ADDENDUM NO. 1

FEBRUARY 18, 2004

ALPHA DELTA PHI FRATERNITY REMODELING
5747 South University Avenue
Chicago, Illinois 60637

HEITZMAN ARCHITECTS
111 NORTH MARION STREET
OAK PARK, ILLINOIS 60301
(708) 848-8844
FAX (708) 848-8845

PROJECT NO. ACE#03130
DATE: 02/18/04
DESIGNED BY: MEN
SCALE: 1/4" = 1'-0"
SHEET NO. MP104-SK1

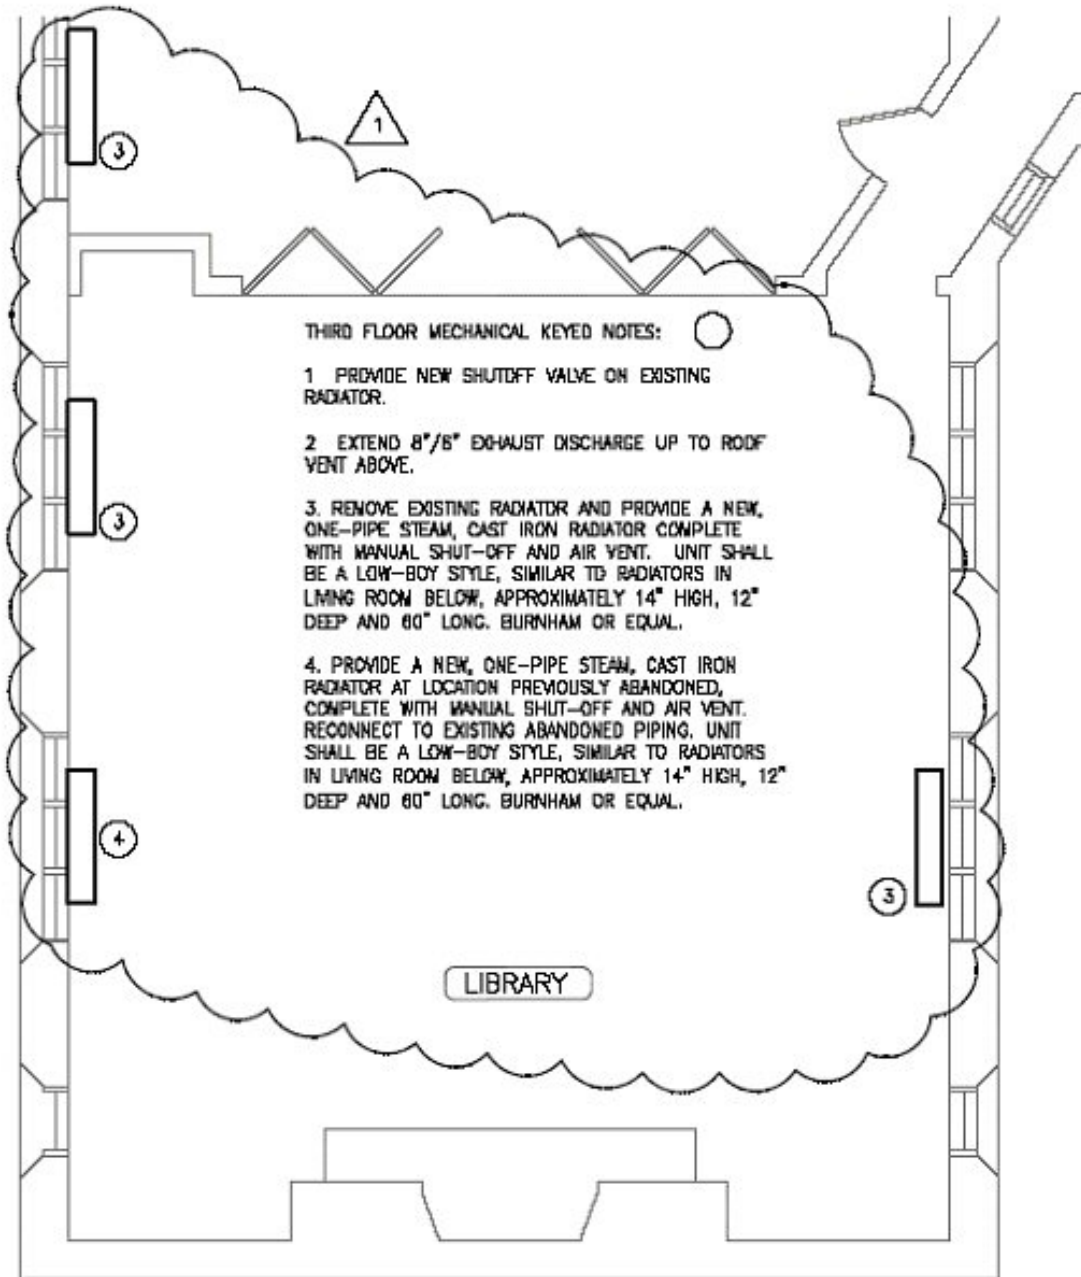
MP104 – Modify Plan in Library and adjacent space. See Attached Sketch MP104-SK1.

1. PROVIDE NEW SHUTOFF VALVE ON EXISTING RADIATOR.
2. EXTEND 8" / 6" EXHAUST DISCHARGE UP TO ROOF VENT ABOVE.
3. REMOVE EXISTING RADIATOR AND PROVIDE A NEW, ONE-PIPE STEAM, CAST IRON RADIATOR COMPLETE WITH MANUAL SHUT-OFF AND AIR VENT. UNIT SHALL BE A LOW-BOY STYLE, SIMILAR TO RADIATORS IN LIVING ROOM BELOW, APPROXIMATELY 14" HIGH, 12" DEEP AND 60" LONG. BURNHAM OR EQUAL.
4. PROVIDE A NEW, ONE-PIPE STEAM, CAST IRON RADIATOR AT LOCATION PREVIOUSLY ABANDONED, COMPLETE WITH MANUAL SHUT-OFF AND AIR VENT. RECONNECT TO EXISTING ABANDONED PIPING. UNIT SHALL BE A LOW-BOY STYLE, SIMILAR TO RADIATORS IN LIVING ROOM BELOW, APPROXIMATELY 14" HIGH, 12" DEEP AND 60" LONG. BURNHAM OR EQUAL.
